Access Compliance Report

Public Rights-of-Way

(Curb Ramps)

Intersection ID: 16415	Main Street: BEVERLY_DR	Cross Street: SHERWOOD_AV	Location: NE
ADA ID: 34C6B240DB6C	Ramp Type: PerpDiag	Initial Pass/Fail: Pass	Overall Compliance: No
			Severity Score: 25.25

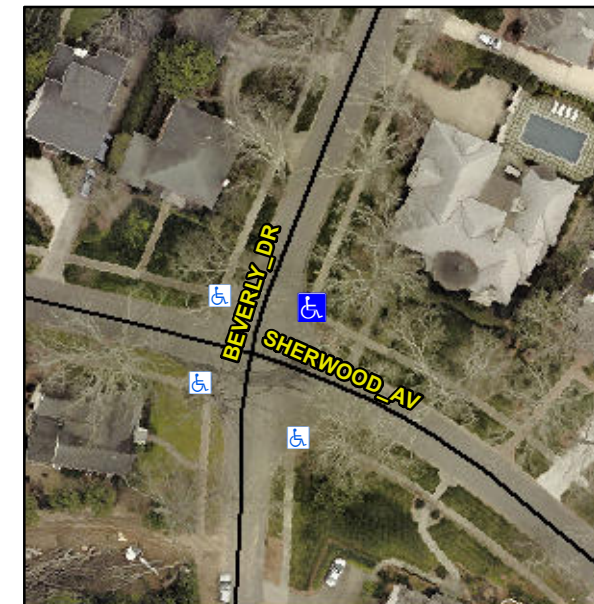
Not Found, R304.5.3, R304.2.1, R304.2.2-Perp, R304.3.2-Para, R305.1.4, R302.7, R302.7.2, R304.5.4

Remove & Replace Curb Ramp With Two New Directional Ramps or Equivalent. Remove & Replace Gutter.
